DESIGN REVIEW BOARD

**June 9, 2026
7:00 PM**

**Town of Bay Harbor Islands, FLORIDA
Design Review Board
ADVISORY BOARD AGENDA ITEM REPORT**

AGENDA ITEM NO. 1

PHOTOMETRIC REPORT

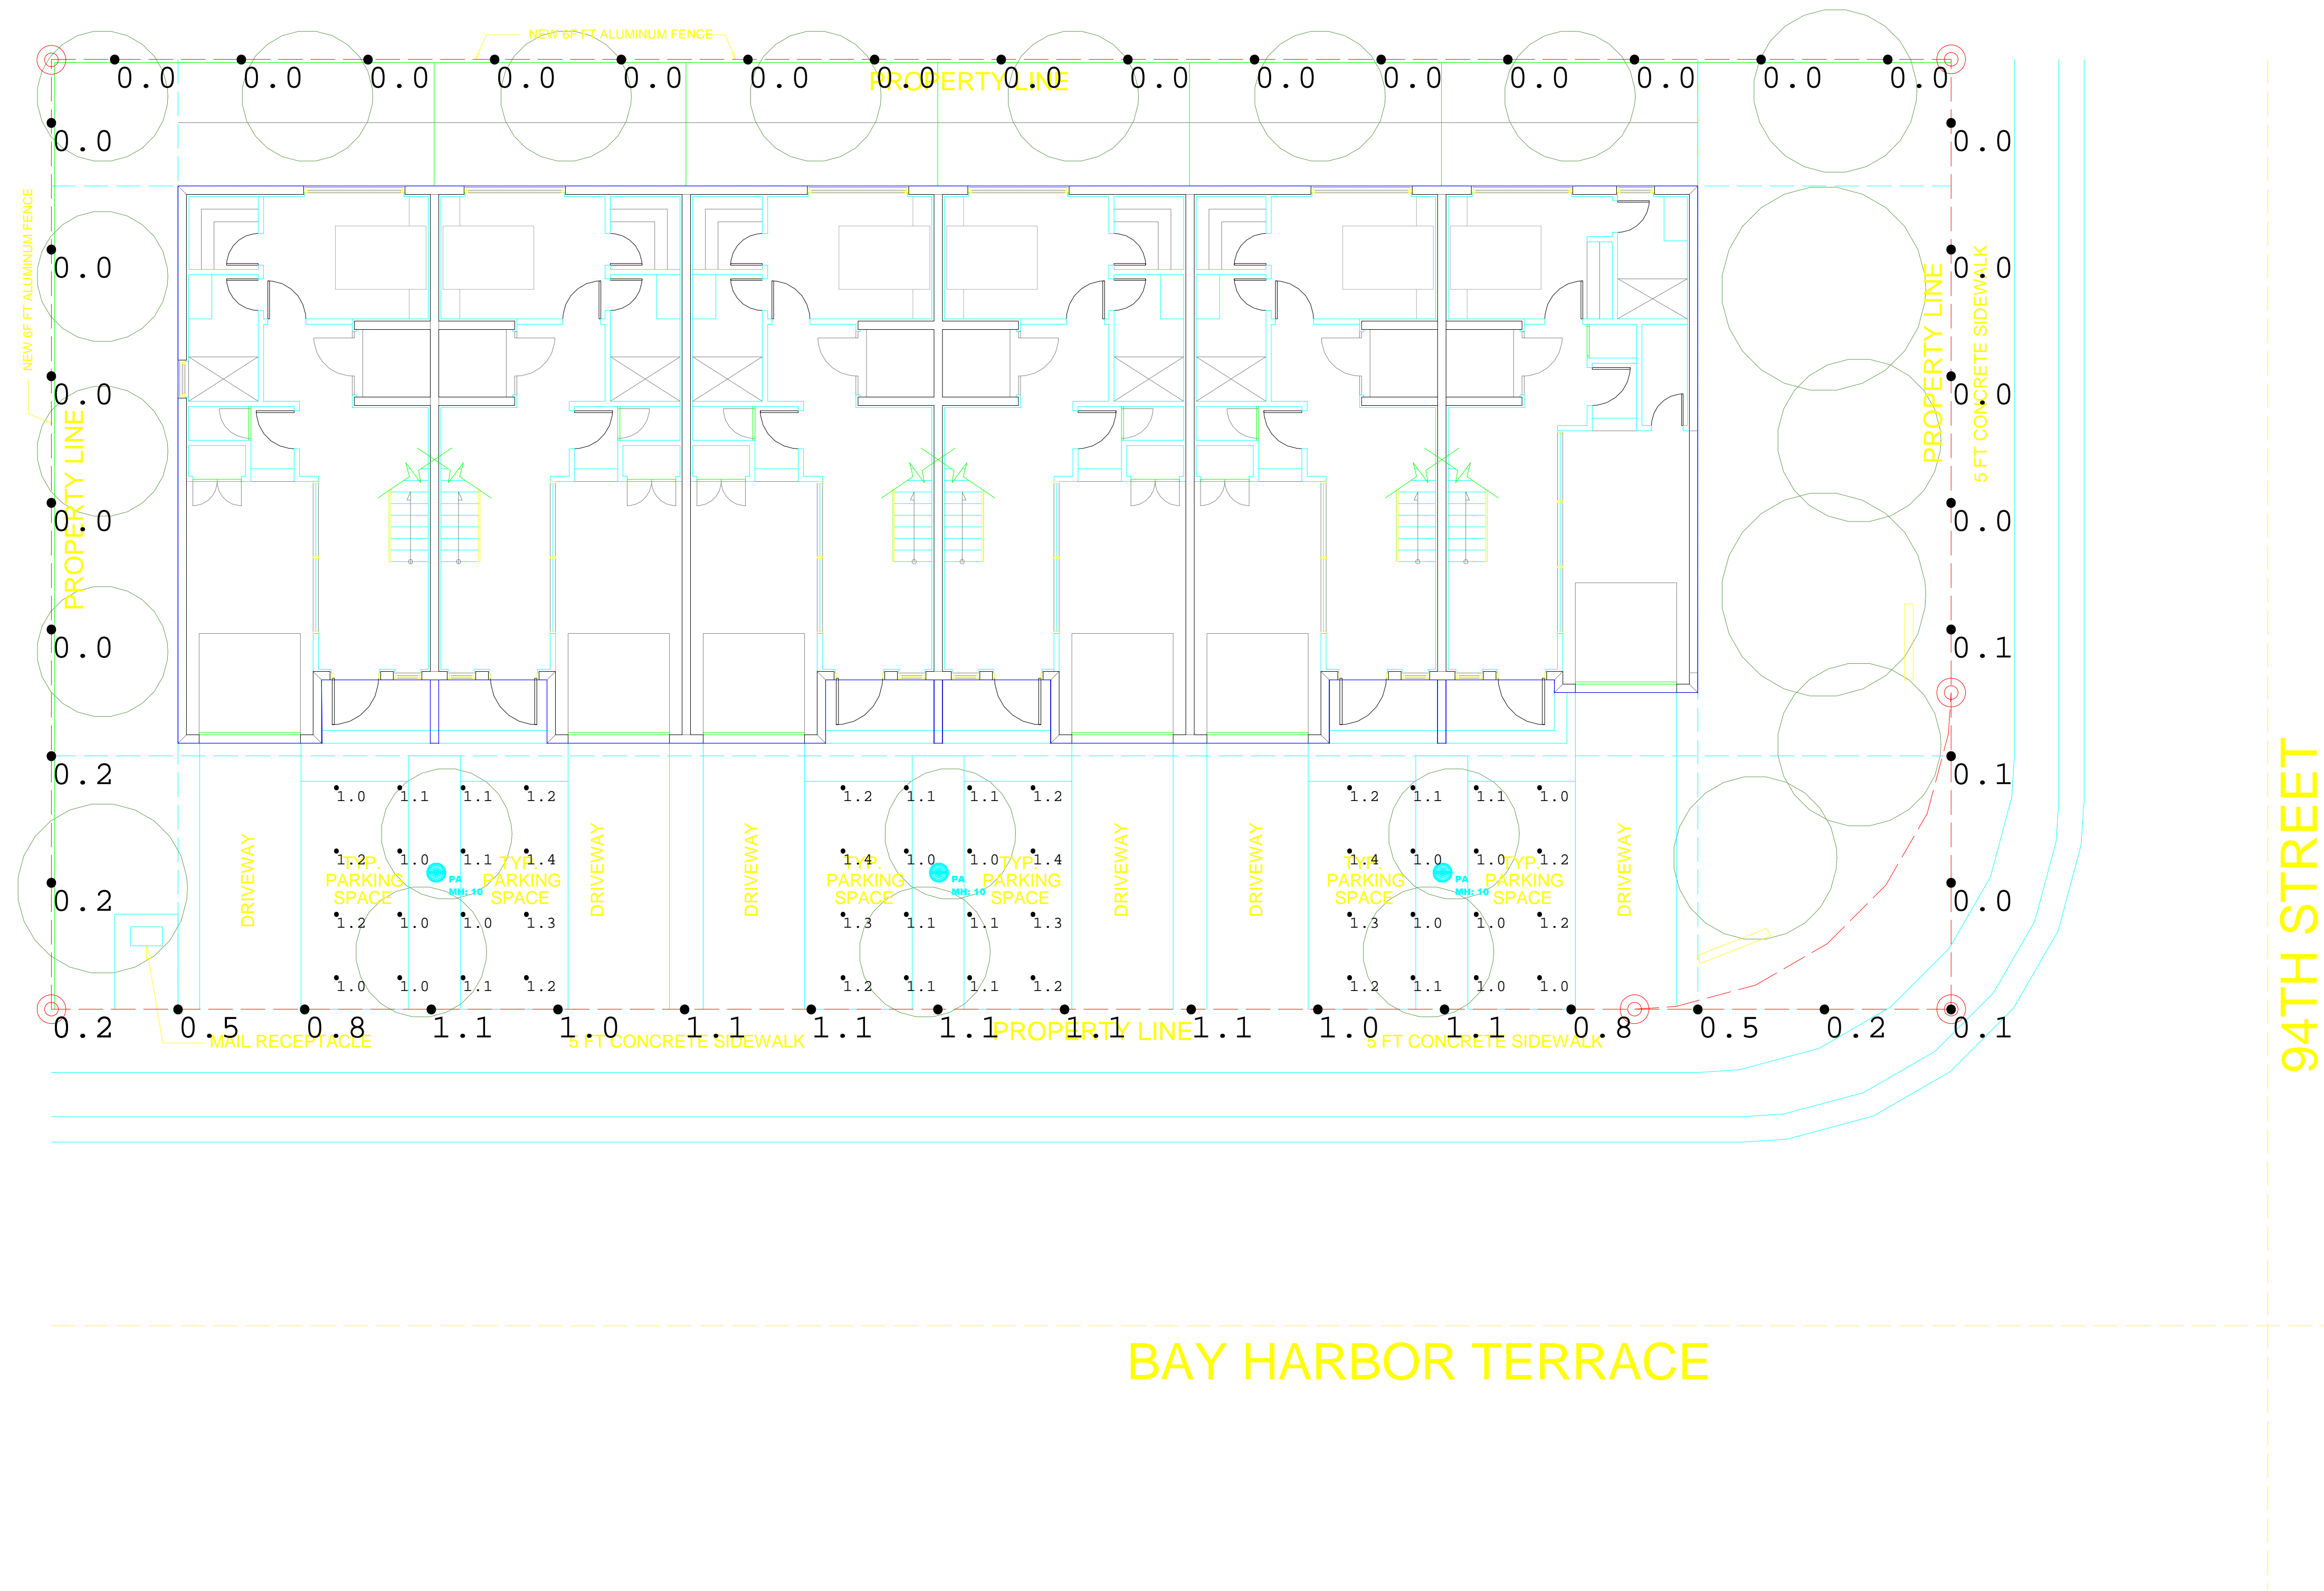
7. **Outdoor Lighting Plan:** The preliminary Photometric Lighting Plan shows general compliance with the Town's Exterior Lighting Code requirements found in Sec. 23-19. At the time of building permit review, the Town staff will ensure the final lighting plan complies with the Code footcandle limitations/requirements.
